APPLICATION NO.	FILING DATE	FIRST NAMED INVENTOR	ATTORNEY DOCKET NO.	CONFIRMATION NO.
10/065,495	10/24/2002	Ronald Scott Bunker	839-1333	9074

Office Action Summary	Application No.	Applicant(s)	
	10/065,495	BUNKER, RONALD SCOTT	
	Examiner	Art Unit	
	William H. Rodriguez	3746

DETAILED ACTION

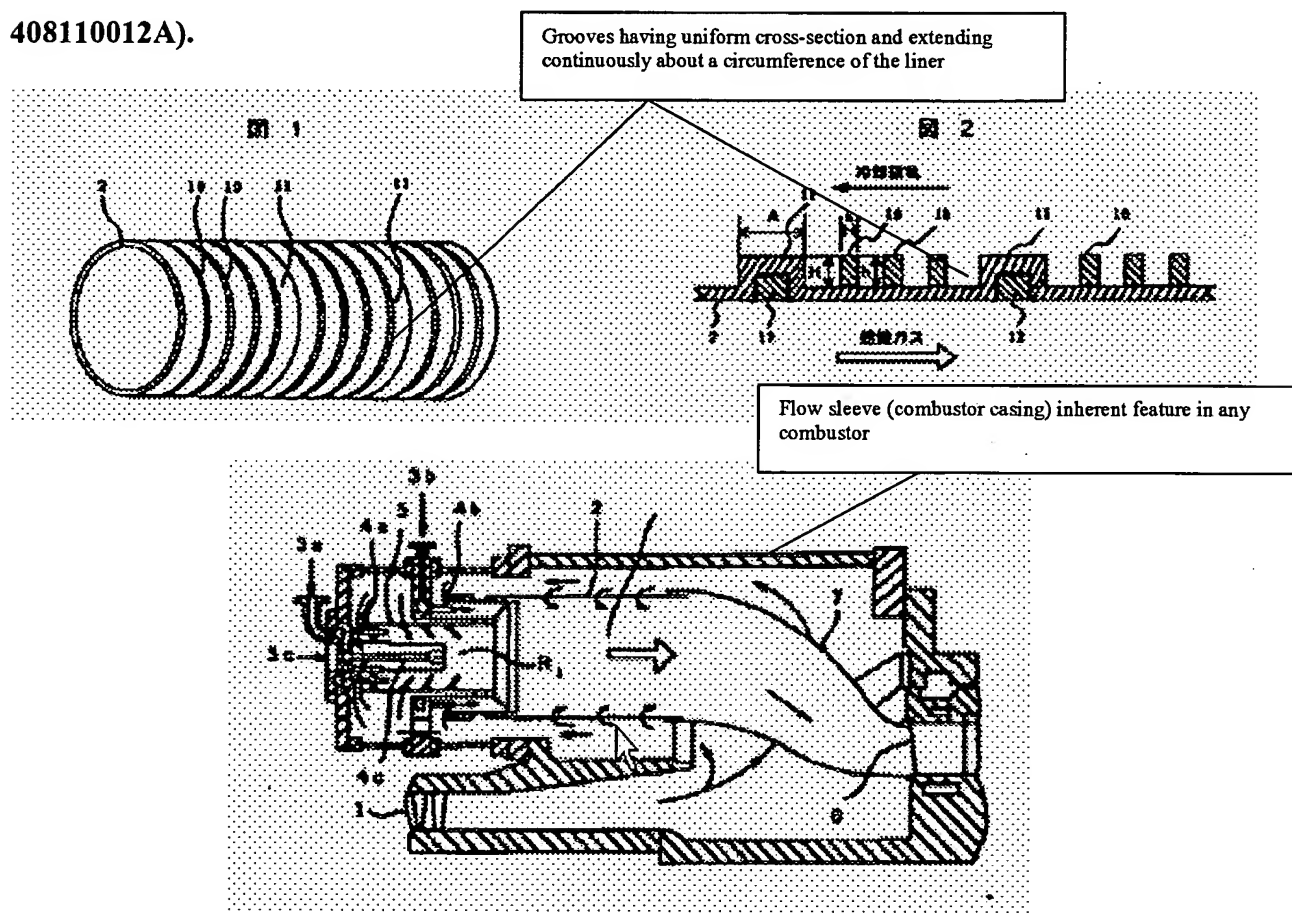
3. Claim 17 is rejected under 35 U.S.C. 102(b) as being anticipated by **Innami et al. (JP 408110012A)**.

Innami teaches a combustor for a gas turbine, the combustor including a liner having a substantially cylindrical shape; a flow sleeve surrounding said liner; a first plurality of axially spaced, continuous circumferential grooves formed in an outside surface of said liner, each groove having a uniform cross-section and extending continuously about a circumference of the liner. See particularly **Figures 1, 2 and 8**.

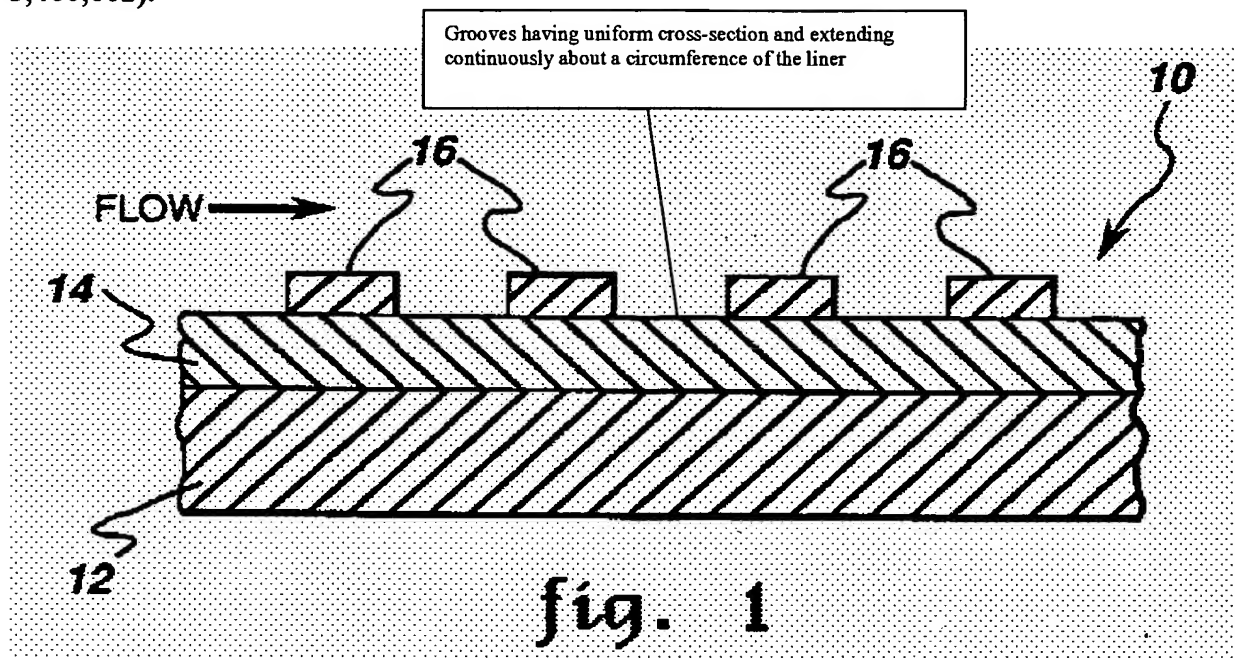
4. Claim 17 is rejected under 35 U.S.C. 102(b) as being anticipated by Correa (US 5,460,002).

Correa teaches a combustor for a gas turbine, the combustor including a liner having a substantially cylindrical shape; a flow sleeve surrounding said liner (not shown but inherent, i.e., casing of combustor surrounding combustor liner); a first plurality of axially spaced, continuous circumferential grooves formed in an outside surface of said liner, each groove having a uniform cross-section and extending continuously about a circumference of the liner. See particularly Figure 1.

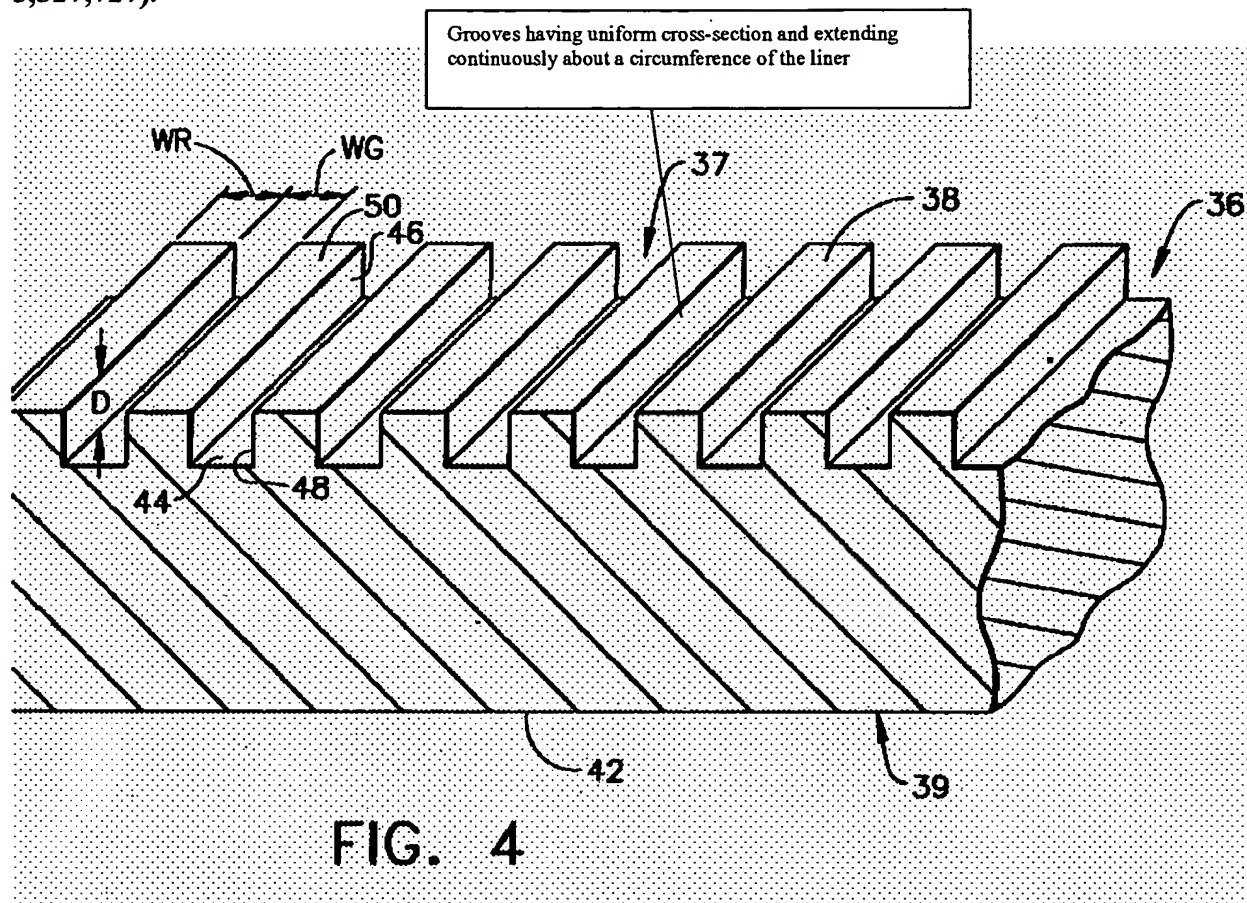
5. Claim 17 is rejected under 35 U.S.C. 102(b) as being anticipated by Ward (US 5,327,727).

Correa teaches a combustor for a gas turbine, the combustor including a liner having a substantially cylindrical shape; a flow sleeve surrounding said liner (not shown but inherent, i.e., casing of combustor surrounding combustor liner); a first plurality of axially spaced, continuous circumferential grooves formed in an outside surface of said liner, each groove having a uniform cross-section and extending continuously about a circumference of the liner. See particularly Figure 1.

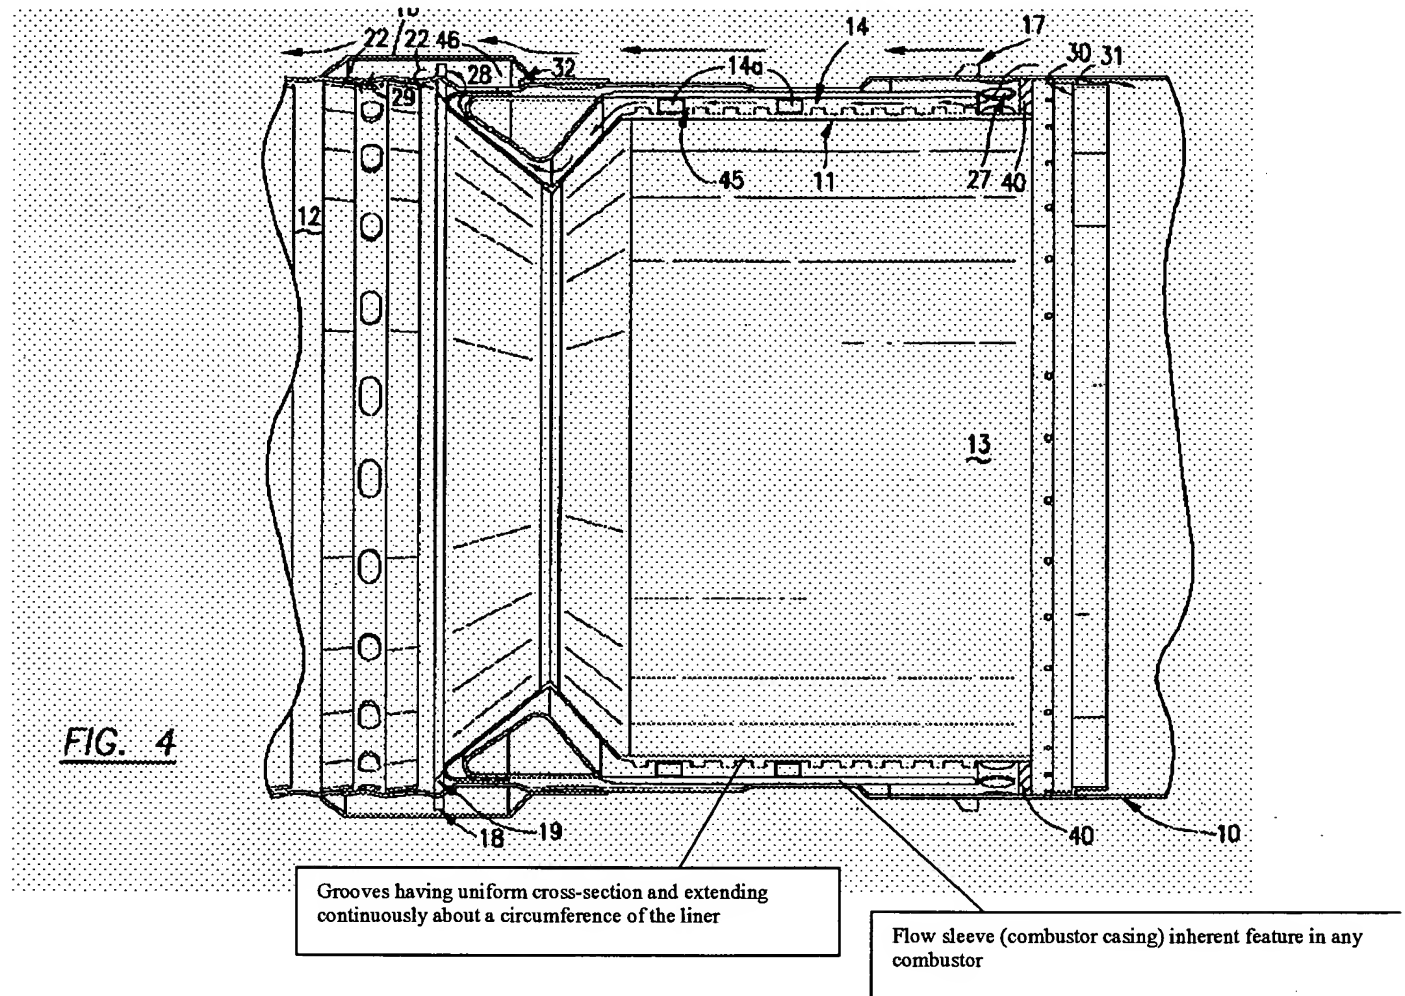
6. Claim 17 is rejected under 35 U.S.C. 102(e) as being anticipated by Kraft et al. (US 6,484,509).

Kraft teaches a combustor for a gas turbine, the combustor including a liner having a substantially cylindrical shape; a flow sleeve surrounding said liner; a first plurality of axially spaced, continuous circumferential grooves formed in an outside surface of said liner, each groove having a uniform cross-section and extending continuously about a circumference of the liner. See particularly **Figures 4 and 6**.

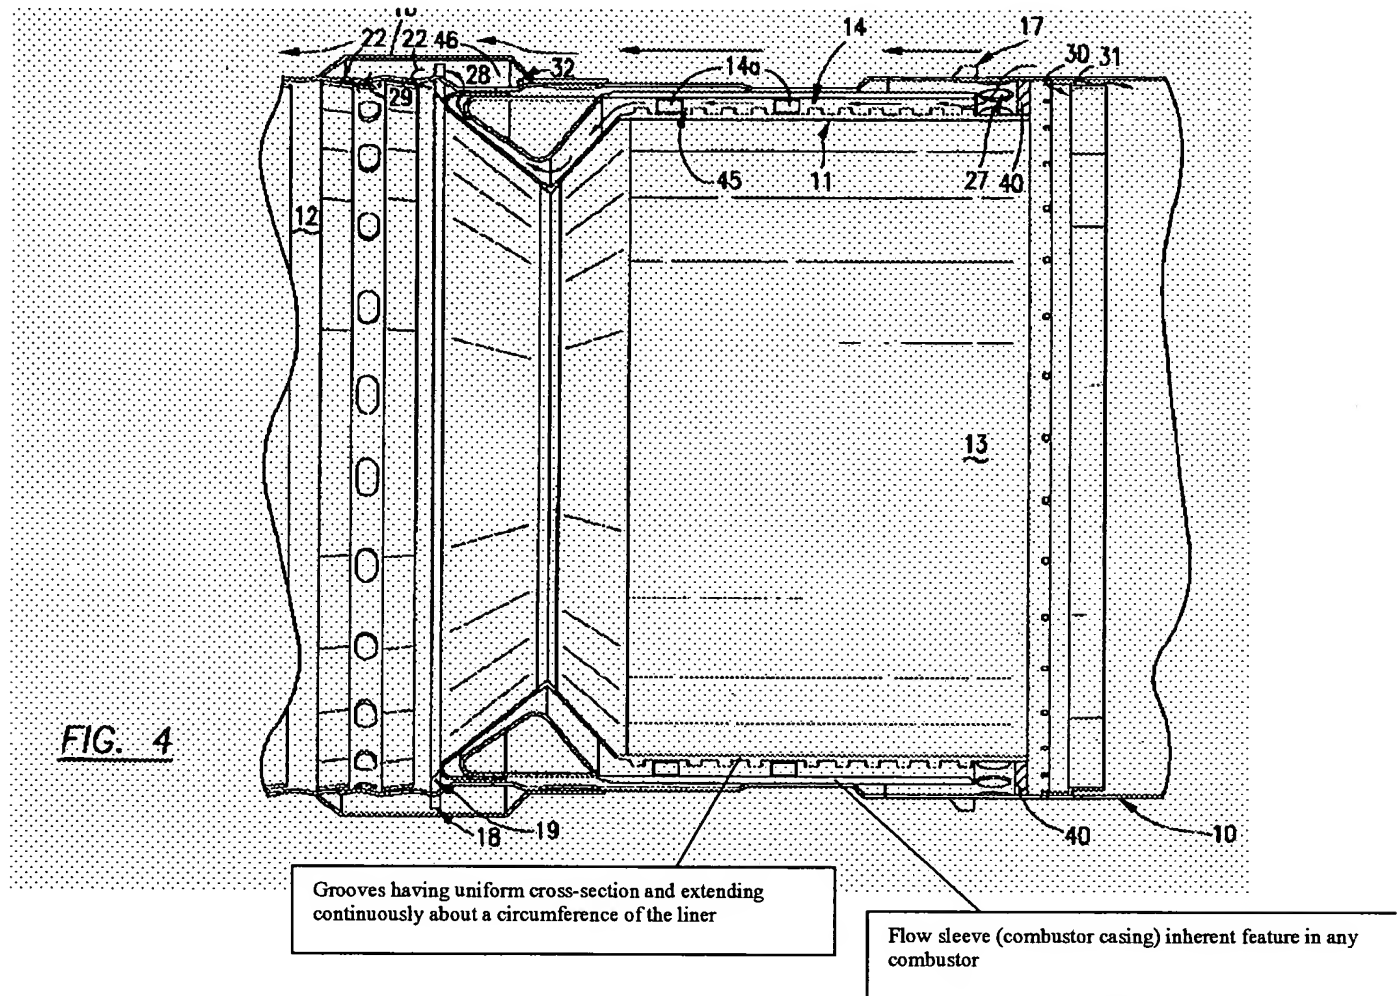
7. Claim 17 is rejected under 35 U.S.C. 102(e) as being anticipated by Kraft et al. (US 6,446,438).

Kraft teaches a combustor for a gas turbine, the combustor including a liner having a substantially cylindrical shape; a flow sleeve surrounding said liner; a first plurality of axially spaced, continuous circumferential grooves formed in an outside surface of said liner, each groove having a uniform cross-section and extending continuously about a circumference of the liner. See particularly **Figures 4 and 6**.
